# GC0077 and GSR018 update Sub-Synchronous Oscillations

# What has been considered in the proposal

## Horizon Nuclear Power

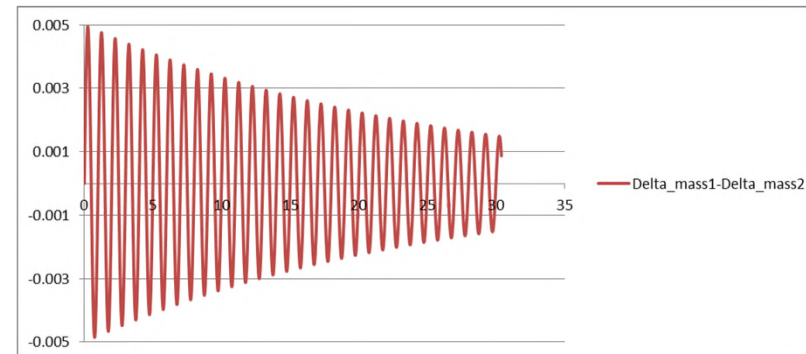
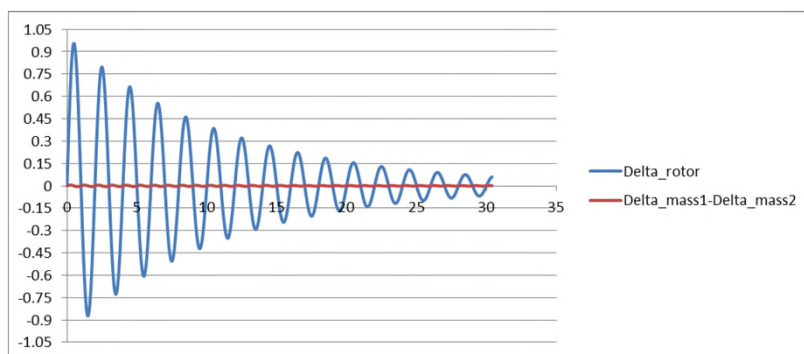
*Clearly any insufficient damping of SSO will have a negative impact on synchronous generators, and may be of a level that will cause long term loss of plant life which is difficult to quantify and attribute to a particular source. Monitoring of at-risk plant appears to be the most effect way of mitigating this, but any monitoring has to go hand-in-hand with an agreed plan on what actions to take if unacceptable levels are observed.*

- Question is related to the applicability of the 12s time constant specified in the system instability criteria to SSO
- Time constants of some mechanical modes are inherently longer than 12s
- The proposal requires that all SSO modes have sufficient damping but time constants below 12s are not guaranteed

## Horizon Nuclear Power

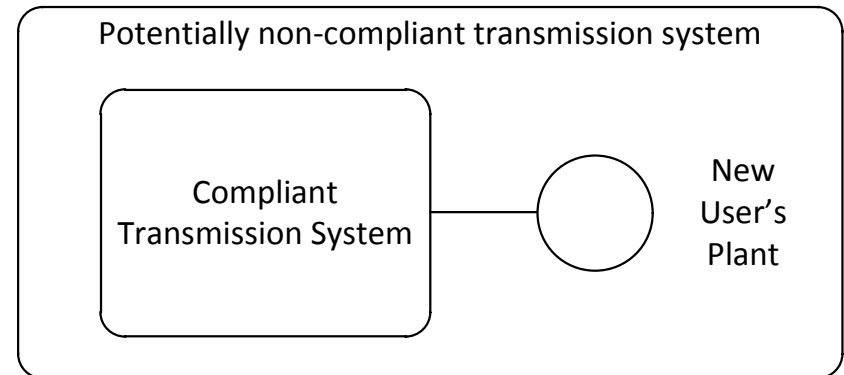
*Although the costs of potential constraints have not been quantified,....*

*The proposal has not quantified the potential capital or operational expenditure.*

*The subject of compensation for damage caused to users' plant as a result of another party has not been addressed. In the event that SSO damage can be directly linked to an SSO source which has not been mitigated correctly, the compensation to the affected users must be reasonable.*

- The conclusions are based on empirical evidence and the assumption that the existing NETS SQSS provides the right balance between operational costs/risks and between capital costs/operational costs for pole slipping events.
- This is not an SSO specific issue. Users' plant might be damaged due to several reasons. This include unacceptable overvoltage, harmonics, pole slipping, etc. It is expected that any damage arising from SSO will be treated in the same manner as anything else.
